**Zamp v.3**  
**2011/09/29**

**New Rect. PCB**

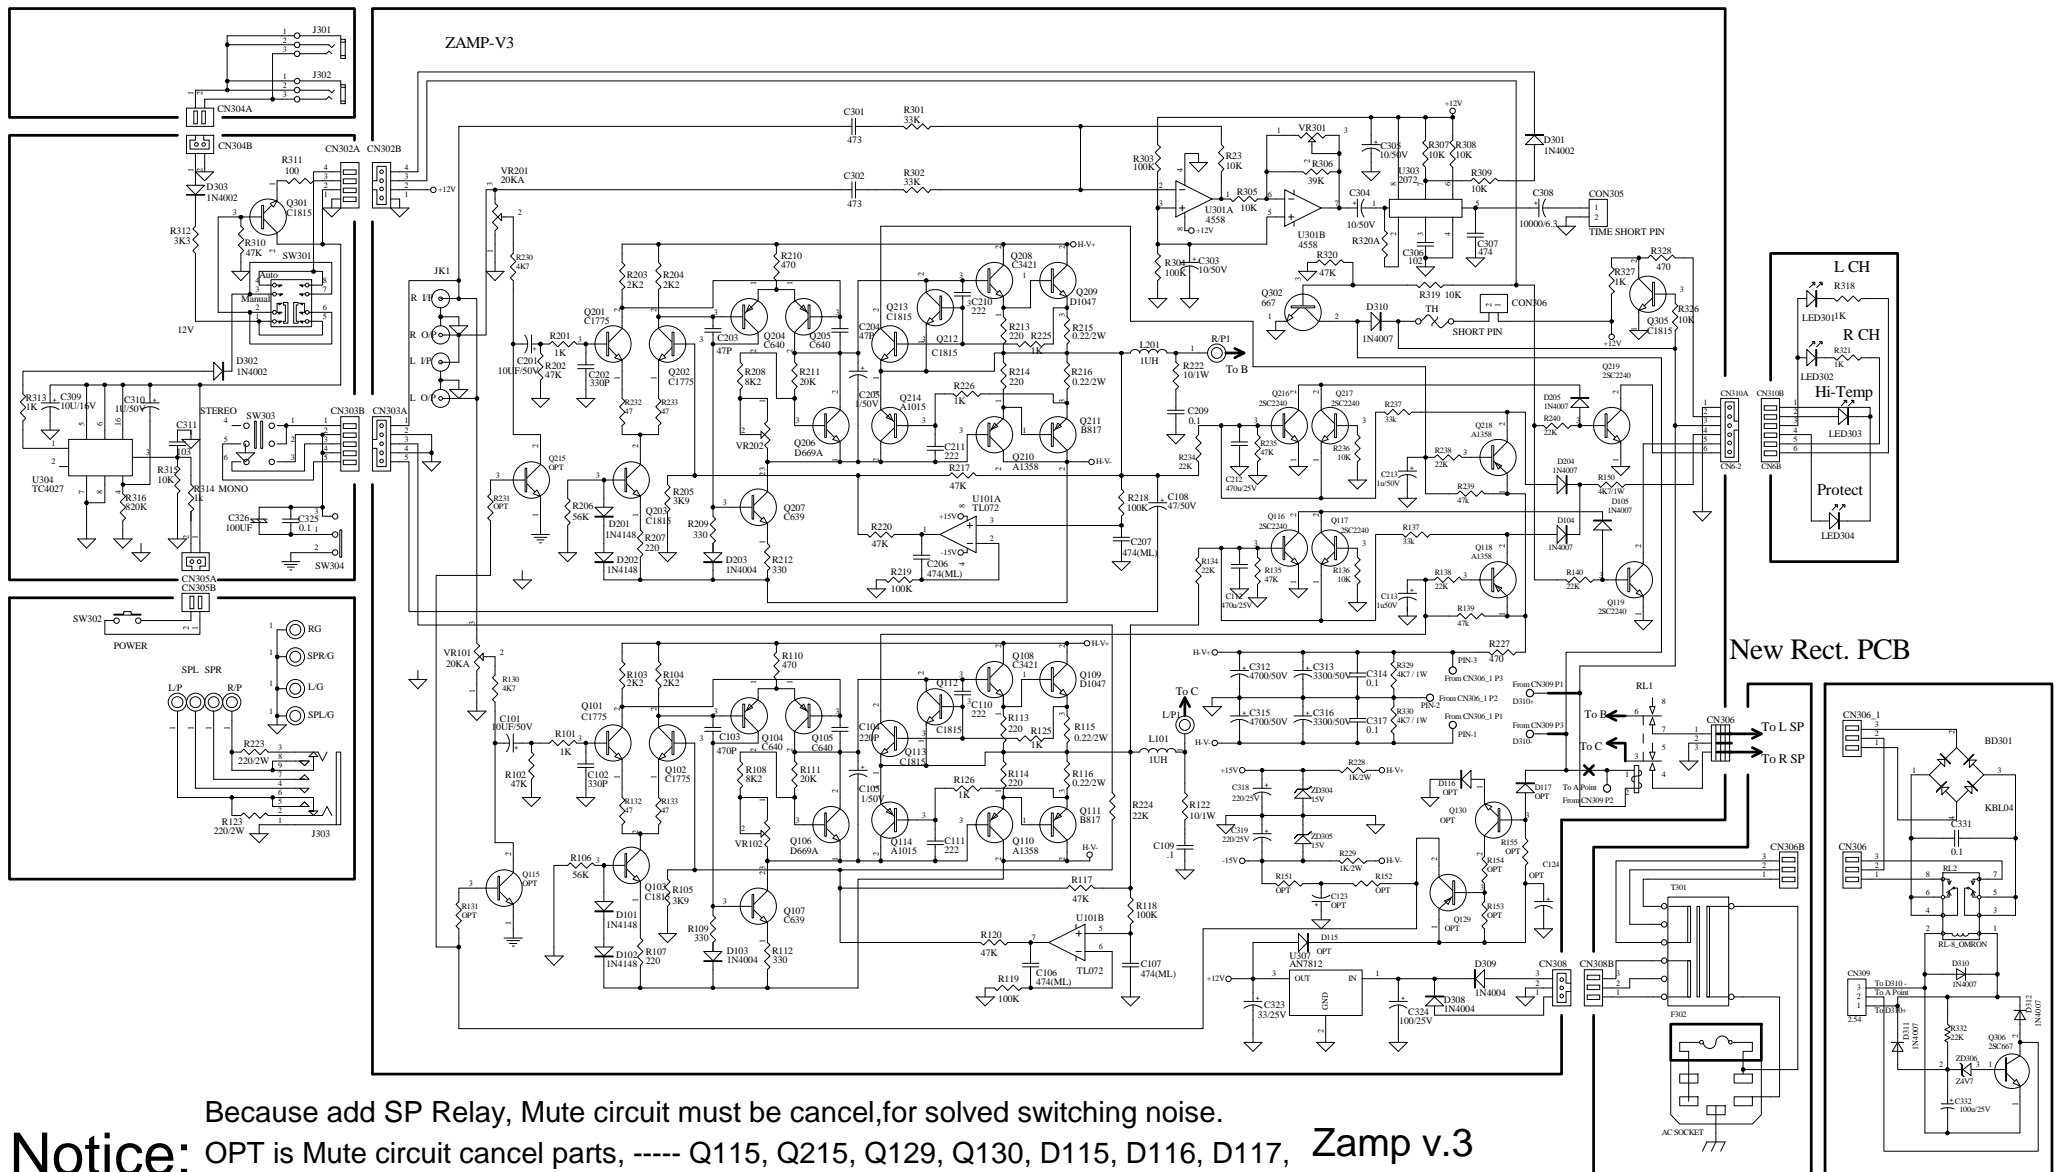
**Notice:** Because add SP Relay, Mute circuit must be cancel, for solved switching noise.  
 OPT is Mute circuit cancel parts, ----- Q115, Q215, Q129, Q130, D115, D116, D117, R131, R231, R151, R152, R153, R154, R155, C123, C124,
